March 24, 2022
Staff Report to the Baldwin Park
Town Review Design Committee

CASE #MPL2021-10047

927 LAKE BALDWIN LANE OFFICE BUILDING

Site Plan

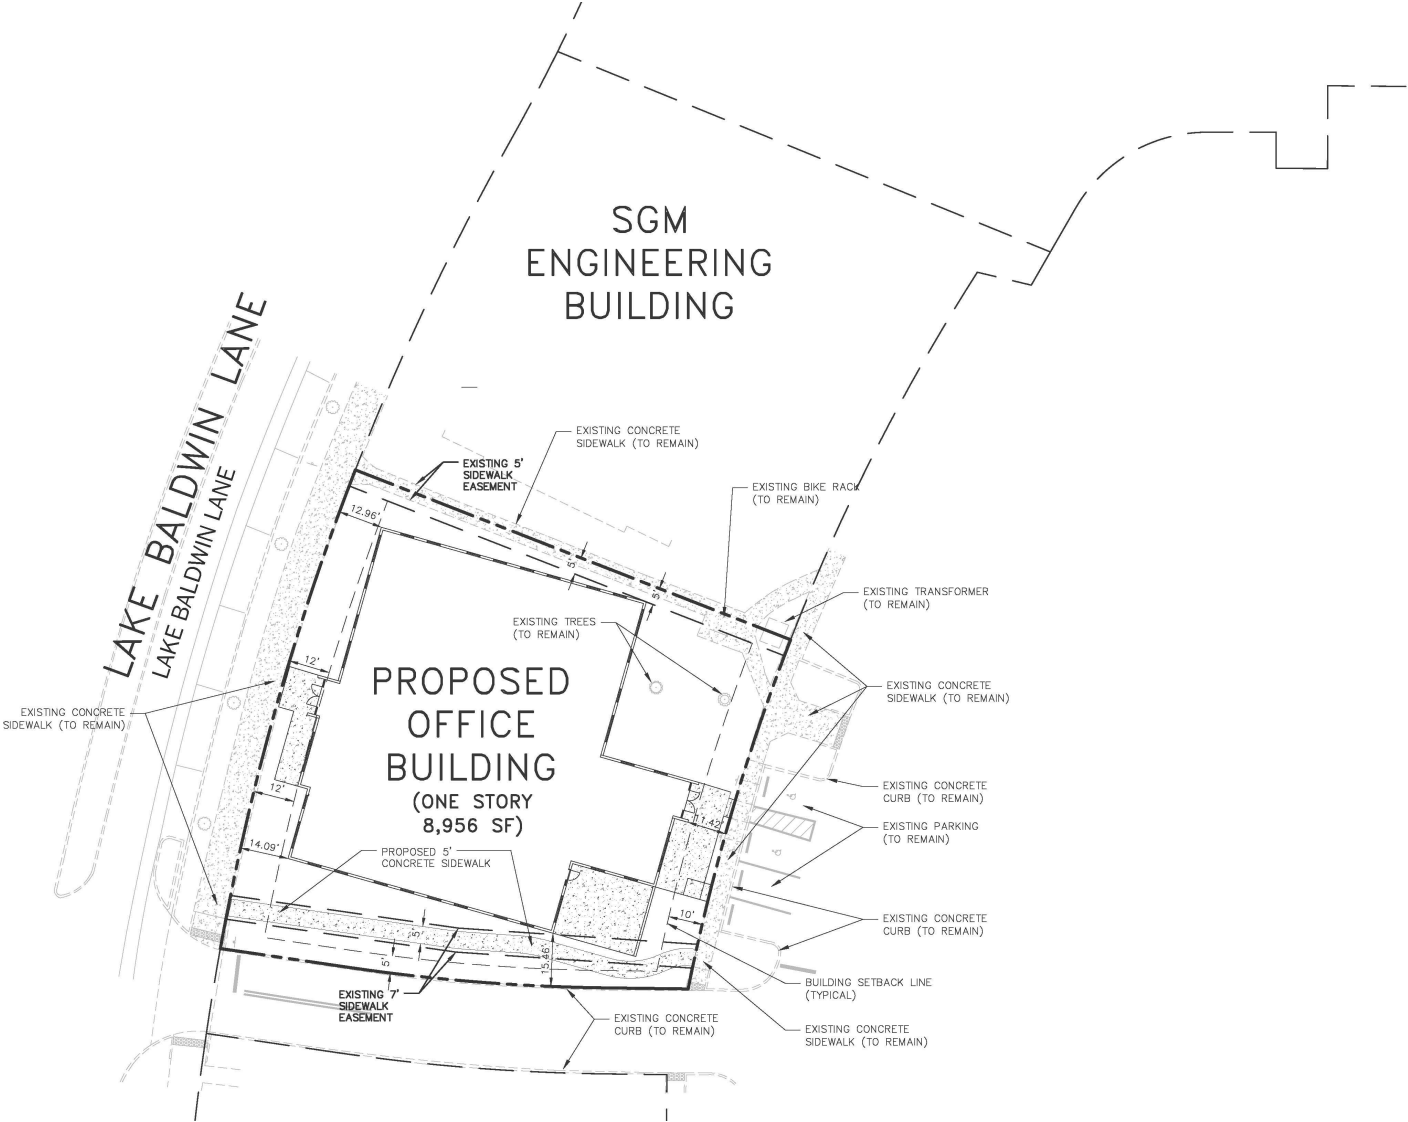
Setbacks: The PD requires a 12-foot front setback/build-to line; 0-foot minimum side setback; 0-foot rear setback; and 5-foot minimum setback from the street R.O.W. for all parking lots. The building has been moved forward towards the Lake Baldwin Lane setback so that the center portion of the building meet the 12 setback and the entry canopy encroaches slightly into the setback (which is allowed).

10. **Sidewalk Easement:** The patio shall be reduced in size similar to that shown in the rendering so that the patio remains outside the sidewalk easement and continues in a straight line.

Proposed East and West Elevations

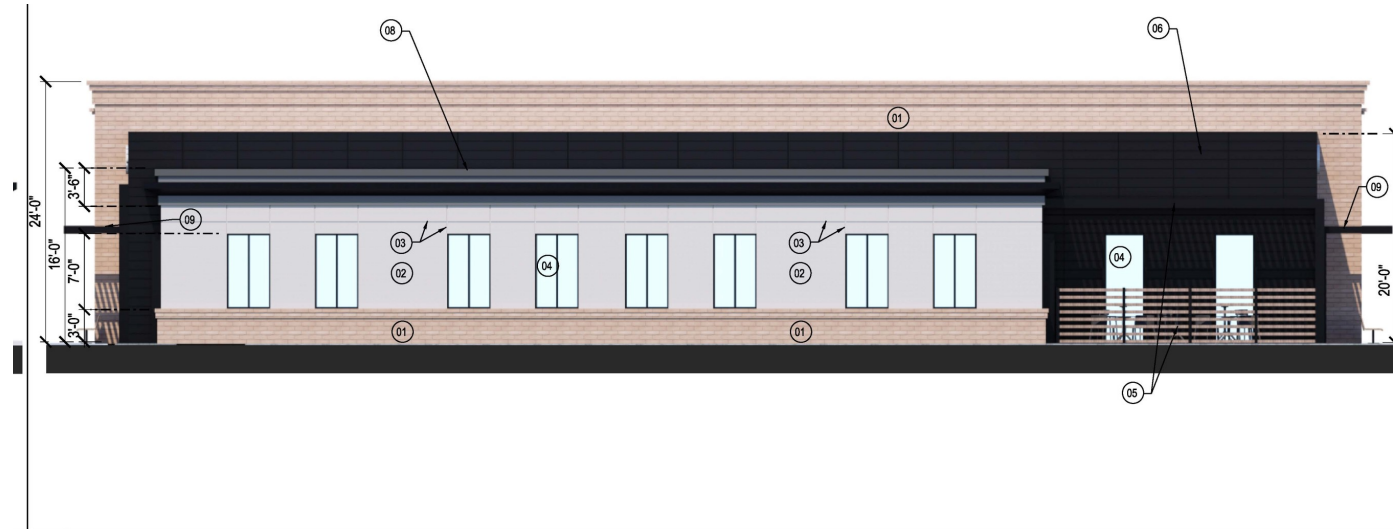
Building Expression: The architectural style of the proposed building is consistent thought-out on all four elevations and provides varied textures and planes throughout. The design is more modern than that typically found in Baldwin Park. Staff has met with the applicant's architect several times to refine the design and staff is pleased with the result. The project, while modern in aesthetic, contains the required base, middle and top along with other features that will allow the design to blend into the design fabric of this area of Baldwin Park. The base and central element is detailed in brick. The flat roof is behind a parapet and accentuated with a modern interpretation of a traditional cornice.

The facades include punched-opening expression for windows with a metal hood surround that adds additional shadow lines and detail. Colors are proposed to be light neutral colors such as light tan, beige-brown brick, bronze window frames, clear solarban glass and black metal accents. Active outdoor space at the southeast corner is encouraged in the guidelines and is screened by a wood slat system.

2. **Architectural Design and Details:** The proposed design is more modern than generally found in Baldwin Park. Staff has worked with the applicant since the initial design and modifications have been made to give the building certain traditional elements including brick base, brick accents, punched windows and modern interpretation of a cornice. The Town Planner shall continue to work with the applicant to review the window details, and material choice and general detailing prior to submittal to Permitting. If the applicant disagrees with the Baldwin Park Town Planner, the project shall return to the BPTDRC for their review.

3. **Roof parapet:** The roof parapet must be a minimum of 3.5 feet tall and may need to be higher to screen equipment.
4. **Backflow Preventer:** Backflow preventer[s] must be located so as to not be directly visible from the right-of-way and be screened from view where necessary. They must be clearly identified on the final utilities and landscape plans.
